KOOMPIN- TRANSFER PPU - POU UPDATE 2014 NAIP 2013 AERIAL PHOTO

From: Jordan, Blake
Sent: Tuesday, February 04, 2014 10:56 AM
To: Bohac, Heather
Subject: FW: Koompin Place of Use
Attachments: Koompin 2014 POU update.jpg; Irrigation_POU_2014.dbf; Irrigation_POU_2014.sbn; Irrigation_POU_2014.sbx; Irrigation_POU_2014.shp; Irrigation_POU_2014.shx

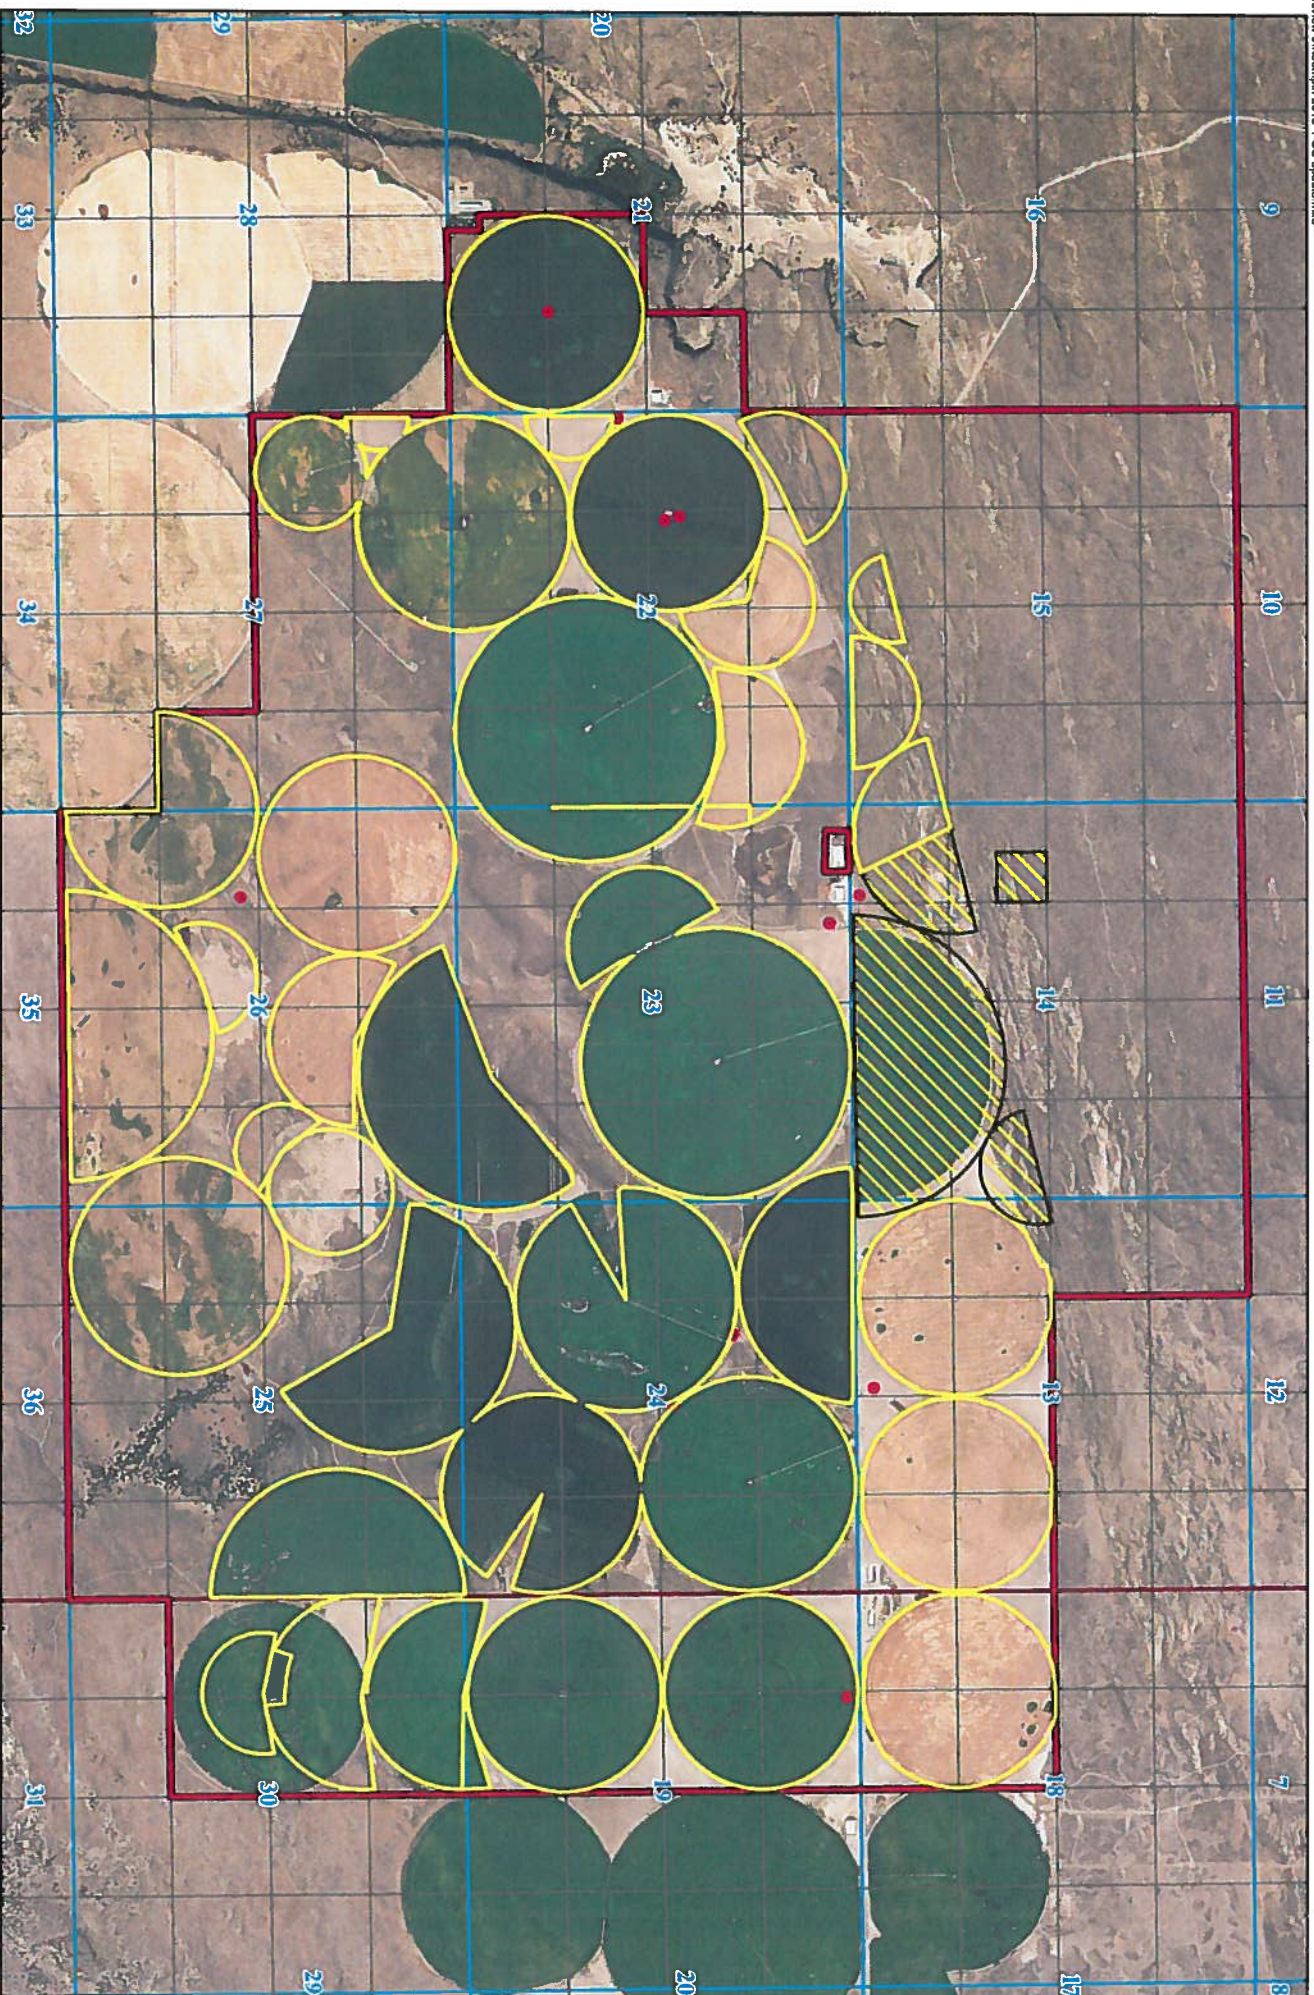
After reviewing KBC's proposed irrigation place of use for the 2014 irrigation season I noticed that there are two sets of water rights with different irrigation places of use within the 6154.0 acre PPU. Water rights 35-7275, 35-7399, 35-13397, 35-13382, 35-13384, 35-13385, 35-13386, 35-13388, 35-13390, 35-13915, 35-13916, 35-13387, 35-13899, 35-13900, 35-4702, 35-13409, 35-13381, 35-13412, 35-13389, 35-7401, 35-13410, 35-13411, 35-13413, 35-13415, 35-13414, 35-2274, 35-7390, 35-7630, 35-2432C, 35-7391C, 35-7863, 35-13905, 35-13906, 35-2172, 35-13703, 35-13897, 35-13898 and 35-14213 when combined are limited to a specific 3434.0 acre place of use within the 6154.0 acre PPU. Water right 35-14308 is limited to a specific 208.0 acres within the 6154.0 acre PPU. Since these groups of water rights are conditioned to specific acres within the PPU and have different combined acre limits we need to keep them separate. Could you please send a map and if possible a shapefile that has a proposed irrigation place of use of 3434.0 acres (large grouped water rights) and a separate shape for the 208.0 acre (35-14308) proposed irrigation place of use?

I also noticed that the authorized point of diversion for water right 35-14308 is only located in the SWSW of 08S, 29E, Section 14. I did not notice this point of diversion on your map. Does KBC plan on drilling this well?

I have attached a new aerial map for you that identifies the 208.0 acres from 35-14308. Water right 35-14308 is leased to the water bank currently and a portion of 35-14308 should be released this spring. However, a portion of 35-14308 will be leased to the water bank through 2016. Rental applications have been filed to make up for the acres not currently allowed to be irrigated under 35-14308 at this time.
